OUR TOWN HALL PROJECT

PROJECT STATUS	RIBA STAGE 5
CLIENT	MANCHESTER CITY COUNCIL
PROJECT	OUR TOWN HALL
DRAWING TITLE	Rooflight WCR01 Existing and Proposed - plans
SIZE & SCALE	A1: Scale as Stated
DRAWING STATUS	ISSUED FOR CONSTRUCTION
JOB NUMBER	236959
DRAWING NO.	OTH-PUR-TH-RF-DWG-A- 7480
REV	02

I
7480
1:20
INTERNAL LANTERN PLAN - AS EXISTING

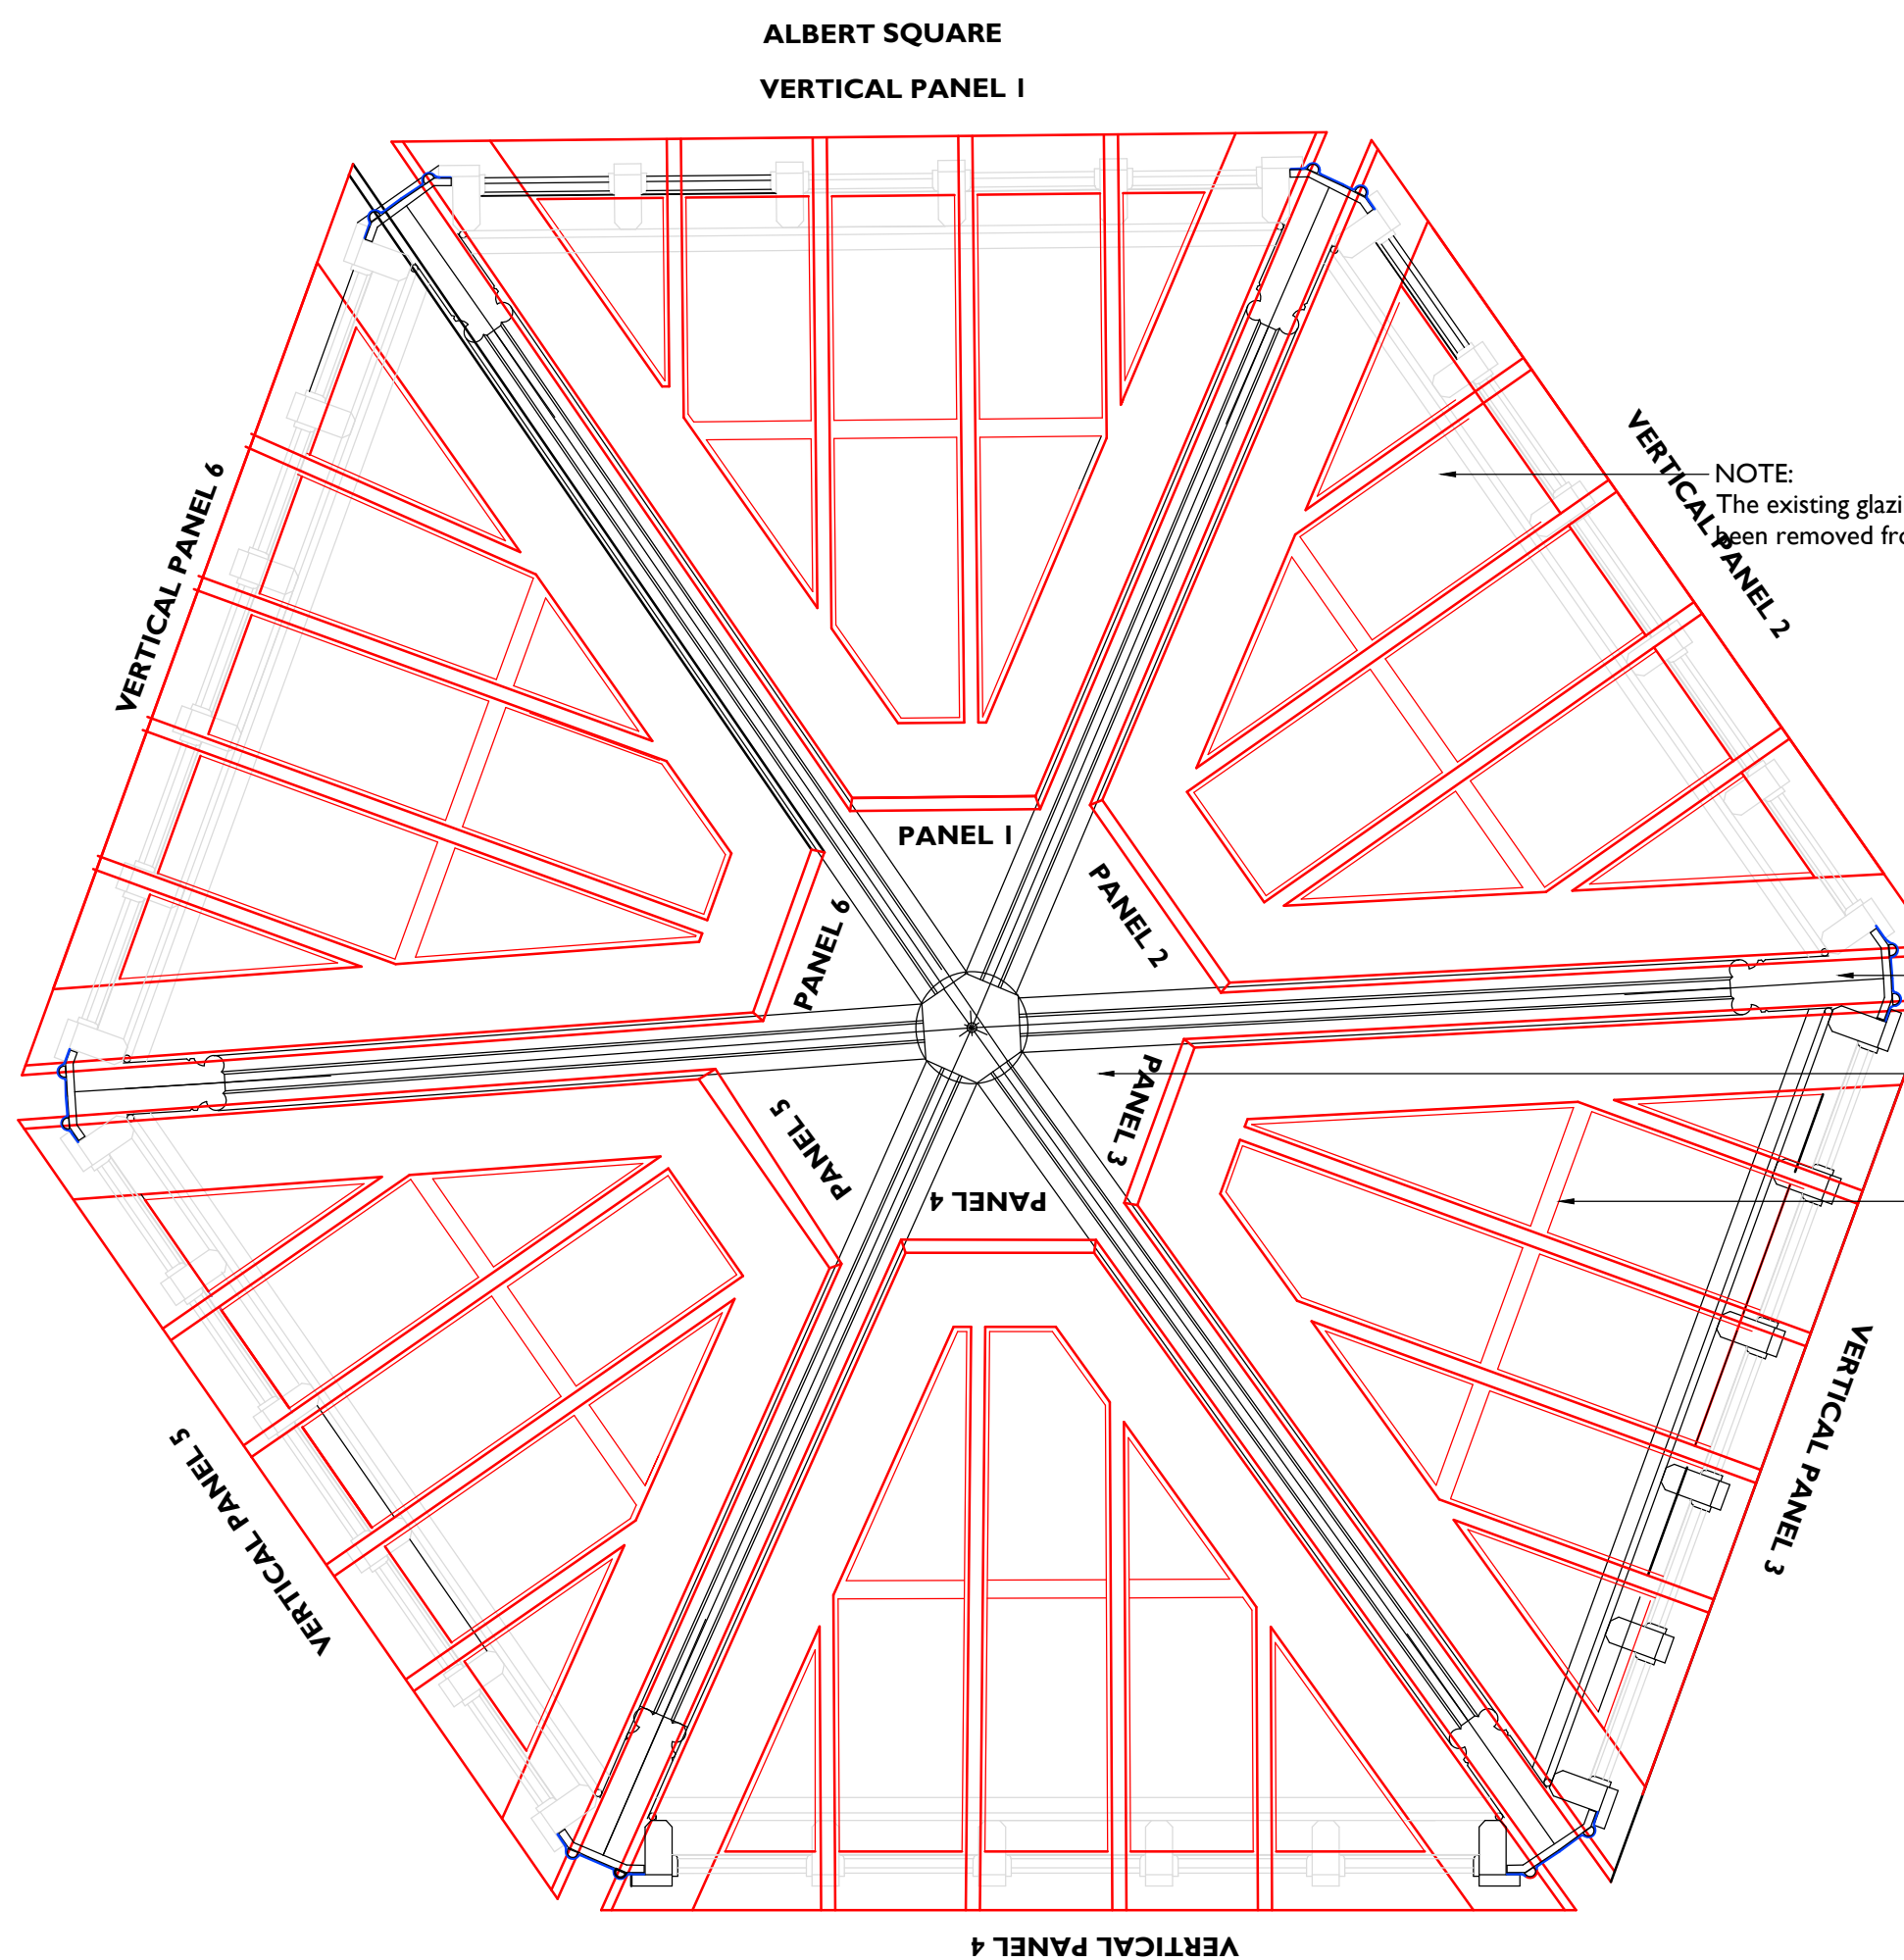
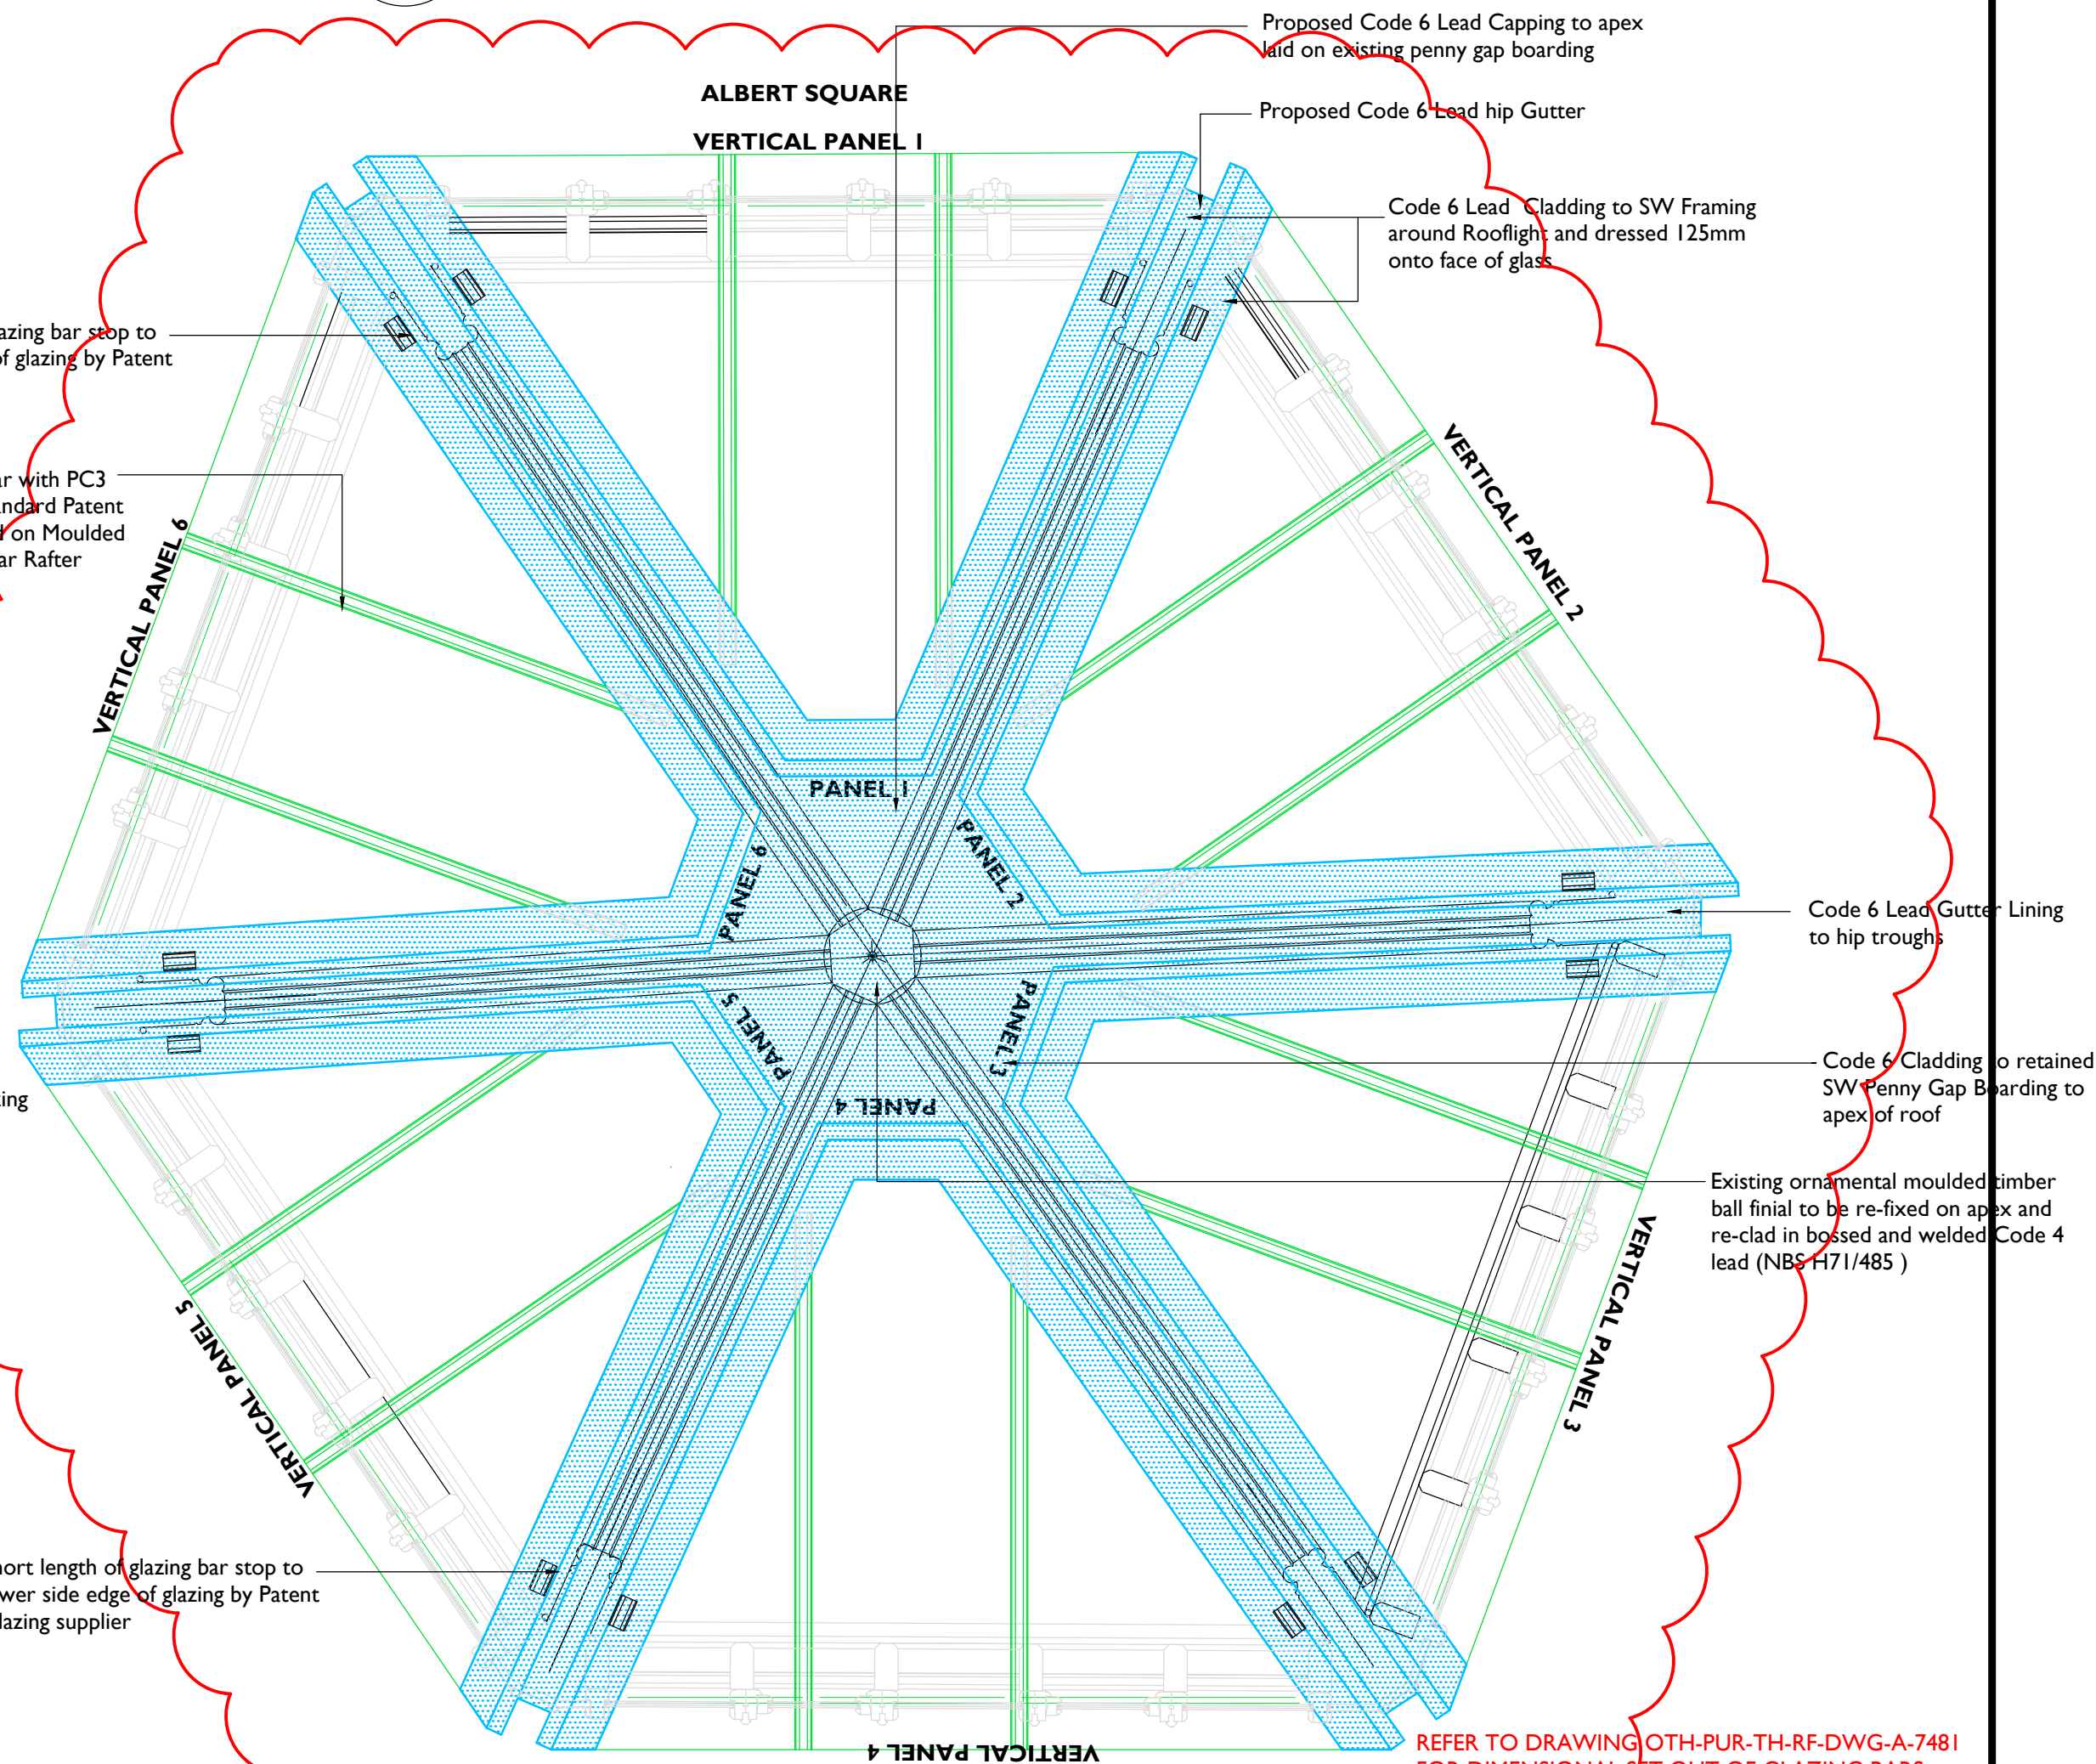
Rev 02	12/11/2023	JC	SE	Set-out of glazing bars and lead hip guttering amended slightly
Rev 01	04/10/2023	JC	SE	PPC Verge Flashings changed to lead. Timber Glazing Bars increased in depth and changed from Oak to C24 Douglas Fir. Retention clips added to lower edge of glazing
29/08/2023	SE	SE	First Issue	
ISSUE	DATE	APPROVED	DRAWN	DESCRIPTION
